5DX-65

S E R V I C E N O T E

5DX Series II and 2L

Camera Utility verifies measured solder thickness

Figure 1

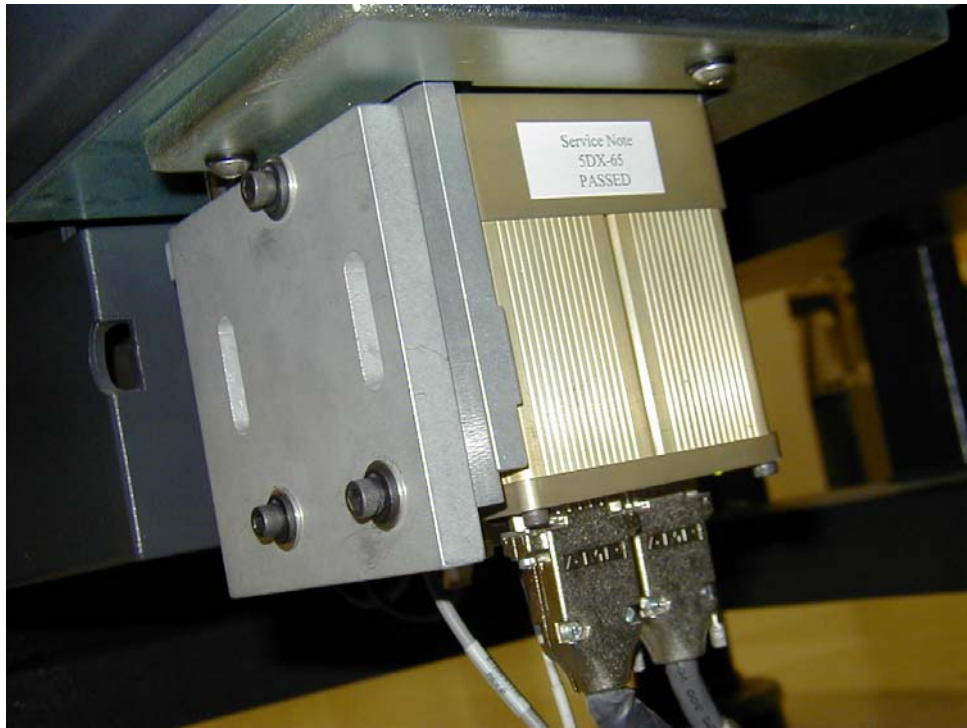
1. If a camera verification label is installed, see Figure 1, then camera has already been verified.
